CITY OF BOULDER LANDMARKS BOARD MEETING

DATE: Wednesday, December 2, 2015

SUBJECT: Public hearing and consideration of a Landmark Alteration Certificate application to demolish an existing house built in 1957 and, in its place, construct a new 2,500 sq. ft. house at 2110 4th Street in the Mapleton Hill Historic District, per section 9-11-18 of the Boulder Revised Code (HIS2015-00254).

Figure 13. Proposed Site Plan

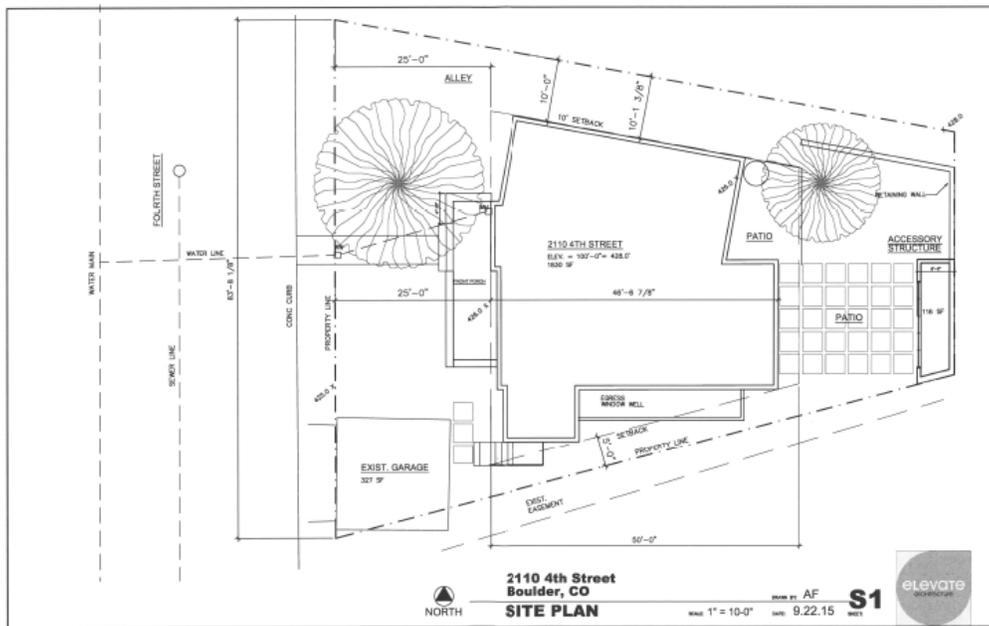
- In terms of mass, scale, height, proportion and style, staff is of the opinion that the proposed design is generally inconsistent with Section 2, Site Design and Section 6, New Primary Buildings of the *General Design Guidelines*, and Section U of the *Mapleton Hill Design Guidelines* and Section 9-11-18(a)&(b)(1-4) of the *Boulder Revised Code*.

In plan, the proposed new house is shown to be located at approximately the same location as the existing house. The existing house is located approximately 26' from the west property line and the proposed house is shown to be located at the 25' front yard

setback. The existing house measures approximately 35' wide and 26' long, with a 21' by 8' shed-roof portion located at the rear of the house. The proposed house is shown to measure 46'-6" long and approximately 50' wide with the north wall creating an oblique angle running parallel to the north property. Currently the alley provides access to at least one property to the east. The proposed construction appears to result in removal of the driveway and curb cut providing access along the north side of the property. The existing contributing garage is shown to be maintained in its current location.

.4	<p><i>The mass and scale of new construction should respect neighboring buildings and the streetscape as a whole. Site layout, porch size and placement, entry level and location, roof line, and door and window sizes and patterns should harmonize with the historic context rather than compete with or copy it.</i></p>	<p>Multiple forms, truncated gable tower and oblique building angles at north will all be highly visible and alter character of the site in a manner that likely will be incompatible with streetscape and southwest section of Mapleton Hill. Consider redesign to provide for full-porch area taking cues from historic houses in the district. While simple flat roof forms are occasionally found in the district, gable, hipped and gambrel roof</p>	No

The Landmarks Board denies the application for demolition of the non-contributing house and the construction of the proposed 2,500 sq. ft. house at 2110 4th St., as shown on plans dated 09/22/2015, finding that they do not meet the standards for issuance of a Landmark Alteration Certificate in Section 9-11-18, B.R.C. 1981, and adopts the staff memorandum dated Dec. 2, 2015 in Matter 5A (HIS2013-00254) as the findings of the board.
